INSTRUCTION TO SERVICE

ITS: 5944	
SECTION:	Body
WRITTEN BY:	Kevin Robinson
SUBJECT:	Inspect mirror spacer and replace as required.

Figure 1: Enter Description of Figure Here

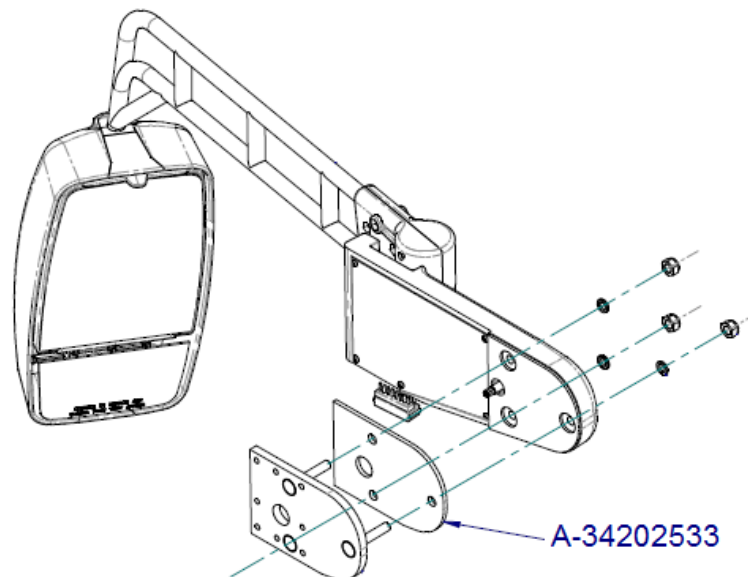
3. If the spacer is not found to be powder coated black, order a new spacer (NF PN A-34202533)
4. Inside the bus, disconnect the mirror harness and de-populate the wires on the mirror side from the connector.
5. Disassemble the mirror and remove it from the bus. Discard the existing spacer. Retain hardware for re-use.
6. Clean the sealant off of the mounting plate, left on the bus and the mirror base.
7. Replace the existing spacer with the new one, re-routing the harness into the coach.
8. Apply a thin layer of clear sealant between the mounting plate and the spacer and also between the spacer and the mirror base. Refer to Figure 1 for exploded view of CS mirror install.

9. Secure the mirror base to the bus with three new nylon lock nuts (NF PN A-87280306).
10. Remove all tools and debris and return the bus to service.
